To: The Mahomet Aquifer Consortium

From: George Roadcap, PhD, Illinois State Water Survey – University of Illinois

RE: Clinton Landfill Permit

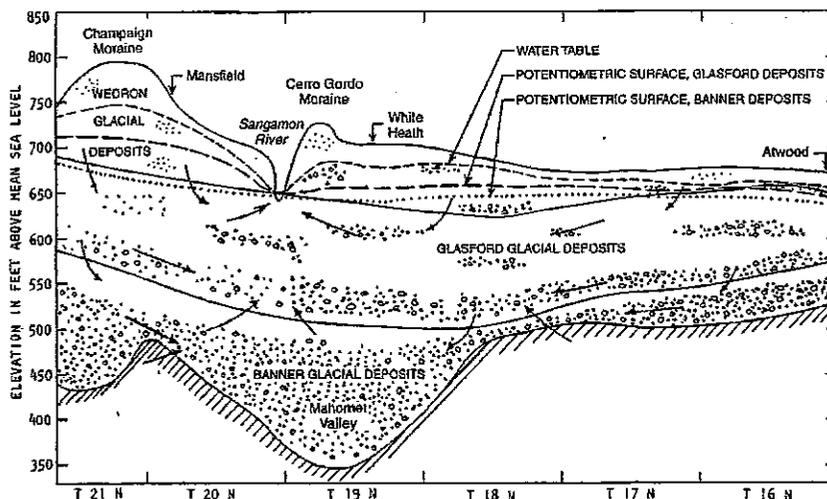
This section describes the results of water sampling done in the shallow units close to the surface and above the Mahomet Aquifer. Because the applicant has sampled these “drinking water bearing sands”, these units must be below the water table. The Roxana Silt has an elevation of approximately 670 msl. Groundwater flow (ie below the water table) is also discussed in the definition of the lower Radnor sand:

LOWER RADNOR TILL SAND: (M) A 1-2 foot thick water-sand sub-unit of the upper Glasford Formation at the base of the Radnor Till, host to 25-30 drinking water wells within a 5 mile radius of the CWU. The unit is located approximately 18 feet below the base of the CWU's lowest liner and hosts groundwater that is monitored before it disperses into recent valley fill of Salt Creek Valley.

The monitoring plan in section 33 GROUNDWATER MONITORING calls for monitoring wells only in the shallowest units with the deepest of these wells completed at an elevation of approximately 630 msl. If the HISTORICAL HIGH WATER TABLE is truly at 483 and 490 feet MSL, then all of the monitoring wells will be dry and completely ineffective in detecting leakage. It would also be inconsistent in the monitoring plan not to have monitoring wells in the Mahomet Aquifer below the stated high water table.
